UNITED STATES PATENT AND TRADEMARK OFFICE

APPLICATION NO.	FILING DATE	FIRST NAMED INVENTOR	ATTORNEY DOCKET NO.	CONFIRMATION NO.
10/553,698	08/23/2006	Bernd Pfannschmidt	PFANNSCHMIDT-2 2005	
²⁰¹⁵¹ HENRY M FE	7590 06/04/200 IEREISEN, LLC	EXAMINER		
350 FIFTH AVENUE			JACOBS, DUSTIN THOMAS	
SUITE 4714 NEW YORK, NY 10118		·	ART UNIT	PAPER NUMBER
			2834	
			MAIL DATE	DELIVERY MODE
		·	MAILDATE	DELIVERY MODE
			06/04/2007	PAPER

DETAILED ACTION

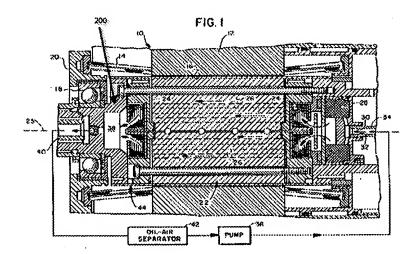
• A rotor clamping ring assembly (2, 21a, and 21b, Fig. 3) for maintaining integrity of the laminated rotor core (3, Fig. 3), wherein the cooling channel protrusion (22, Fig. 3) is part of said rotor clamping ring assembly.

Hasebe et al. '342 teaches that it is known to provide a rotor clamping ring assembly (2, 21a, and 21b, Fig. 3) for maintaining integrity of the laminated rotor core (3, Fig. 3), wherein the cooling channel protrusion (22, Fig. 3) is part of said rotor clamping ring assembly. It would have been obvious to one having ordinary skill in the art at the time the invention was made to provide a rotor clamping ring assembly (2, 21a, and 21b, Fig. 3) for maintaining integrity of the laminated rotor core (3, Fig. 3), wherein the cooling channel protrusion (22, Fig. 3) is part of said rotor clamping ring assembly as taught by Hasebe et al. '342, since Hasebe et al. '342 states that such a modification would provide a cooling circuit for a rotor having a core fabricated of common steel sheets (col. 1, lines 57-60) and a rotor ring assembly to provide axial positioning for the rotor and communication coolant passages for the rotor core (col. 2, lines 9-10 and 17-20).
